49 CFR Part 572

Anthropomorphic Test Devices; Hybrid III Test Dummy, ES-2re Side Impact Crash Test Dummy

ACTION: Final rule.

SUMMARY: This document corrects or makes minor changes to some of the drawings incorporated by reference into NHTSA regulations by a final rule published on June 16, 2008, concerning a 50th percentile adult male side crash test dummy called the “ES-2re” test dummy. The corrections and adjustments to the drawings respond to requests from test dummy manufacturers First Technology Safety Systems (FTSS) and Denton ATD (Denton). This final rule also corrects dimensional errors in a figure which depicts the pendulum used in the neck qualification tests of several of the crash test dummies, including the Hybrid III and ES-2re test dummies.

Figure 1: Corrections to pendulum dimensions in Figure 22 of Section 572.33(c)(3)

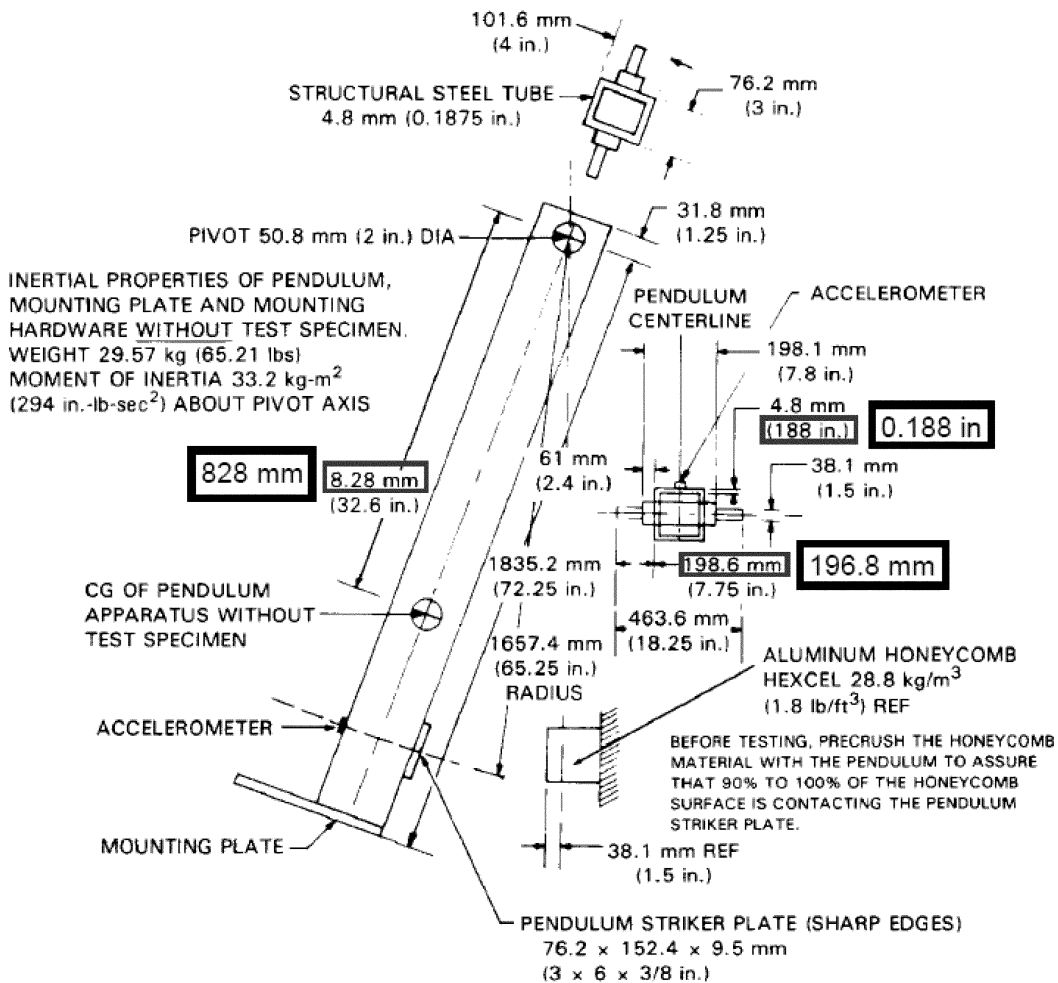
This final rule corrects several dimensional values in Figure 22, “Pendulum Specifications,” of 49 CFR part 572. This pendulum is used in neck qualification tests for the ES–2re as well as other adult crash test dummies, including the Hybrid III 50th percentile male and 5th percentile female frontal crash test dummies, the SID–IIIsD 5th percentile female side impact dummy, and the SID and SID/HIII side impact crash test dummies. The dimensional corrections are listed below and shown in Figure 1 of this preamble, below:

- The 8.28 millimeter (mm) (32.6 inch (in)) dimension is changed to 828 mm (32.6 in);
- The 4.8 mm (188 in) dimension is changed to 4.8 mm (0.188 in);
- The 198.6 mm (7.75 in) dimension is changed to 196.8 mm (7.75 in).

FIGURE 22
PENDULUM SPECIFICATIONS

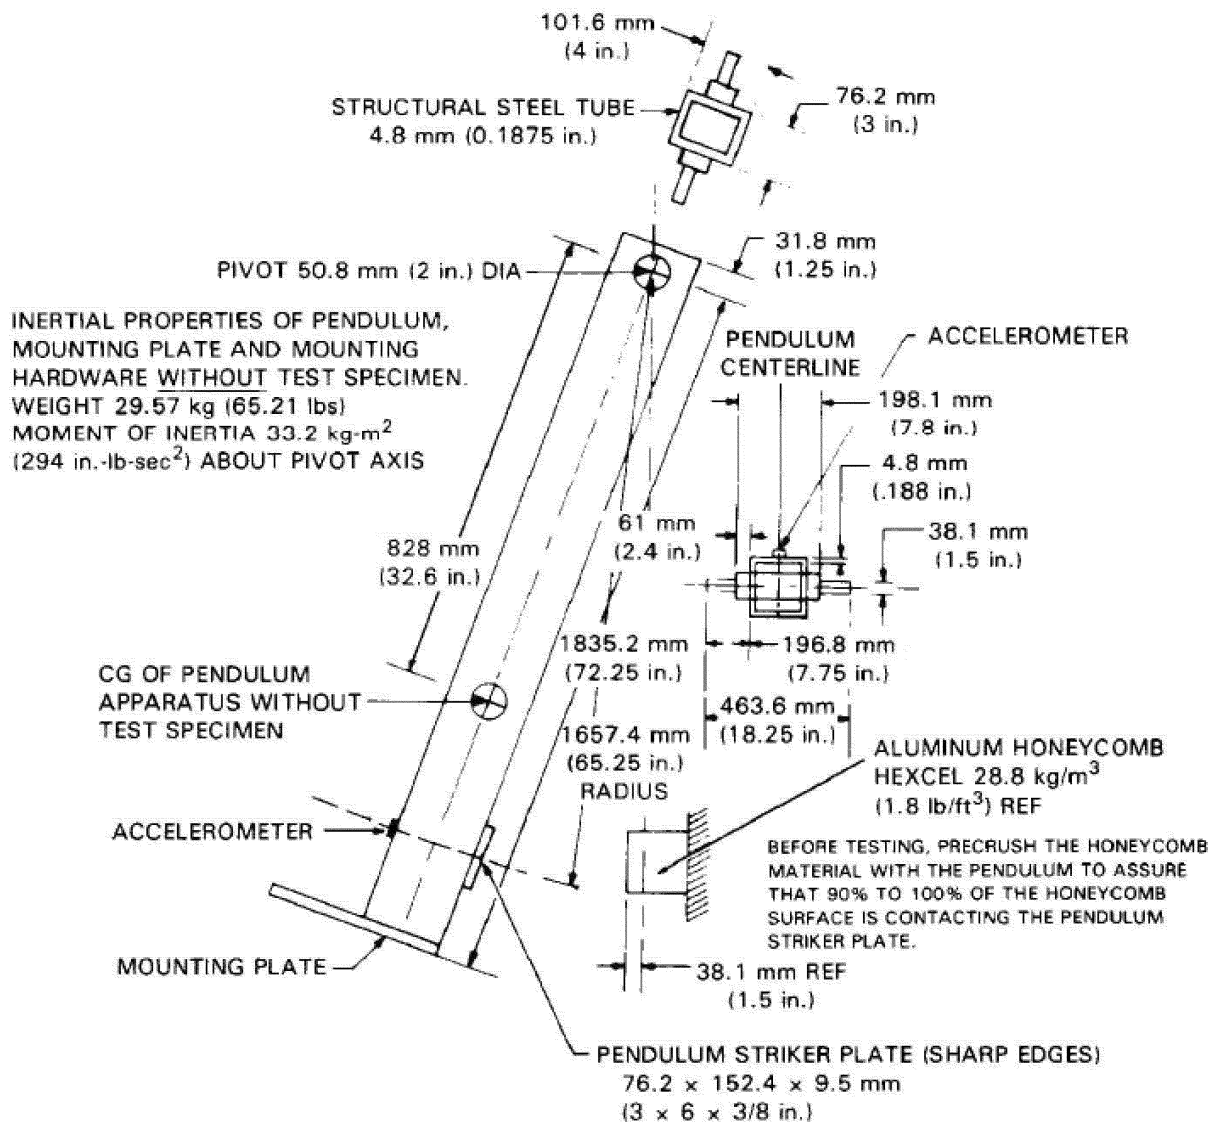
■ 2. In § 572.33(c)(3), Figure 22 is revised to read as follows:
